Tanner's Creek Bottom Ash Complex Assessment Report

Lockheed Martin

June 2009

FIGURE 4

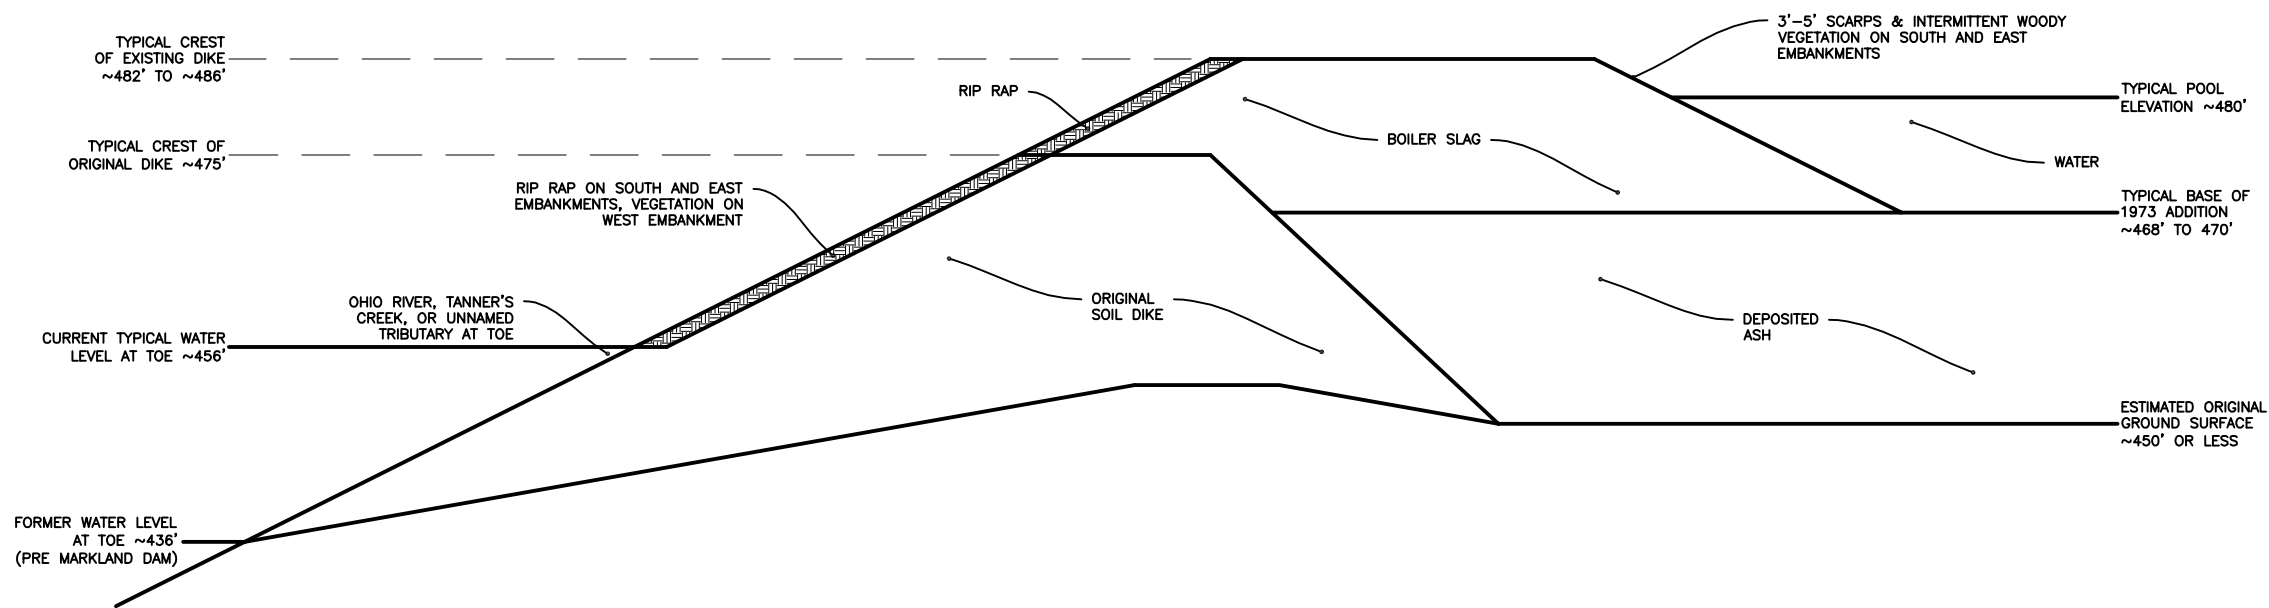
A typical embankment cross section is provided as Figure 4 and views of the embankment slopes can be seen in Photos 1 through 4 of Appendix B.

Photo Number:
6

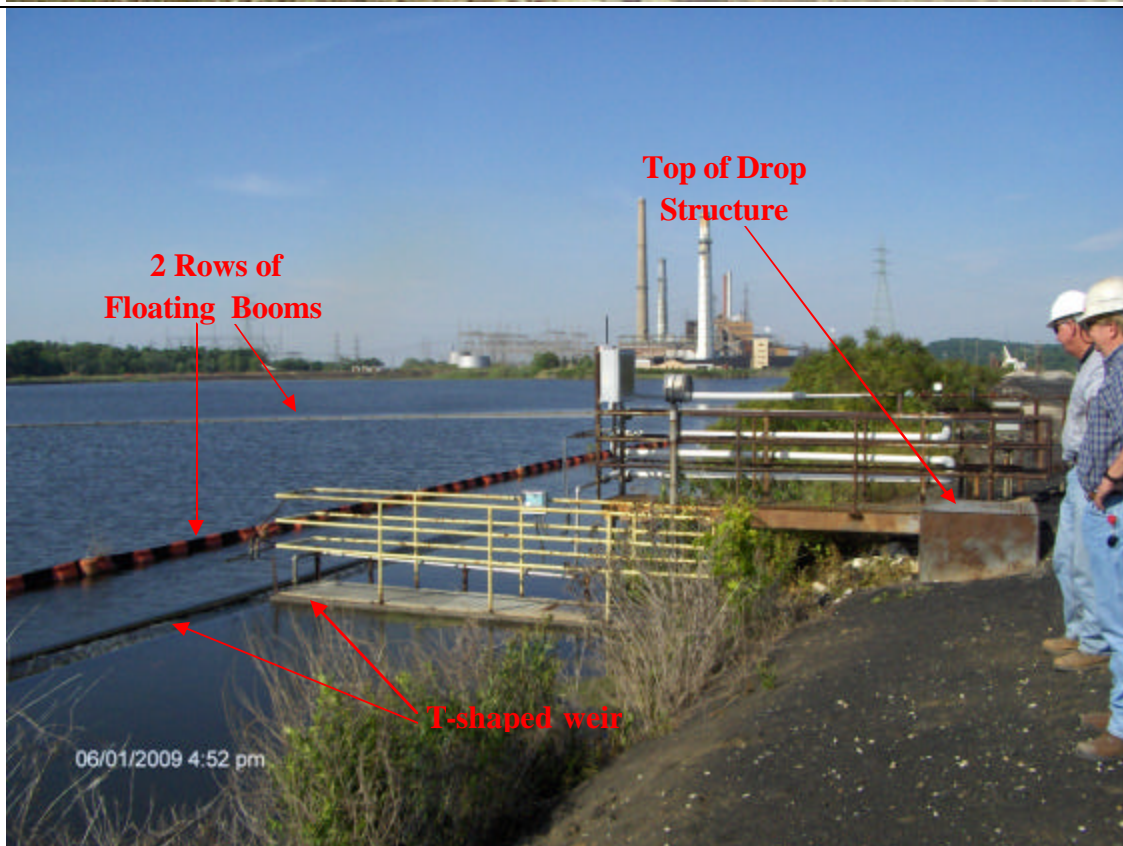
Description:
Decant weir. See sketch in Appendix A for additional details.
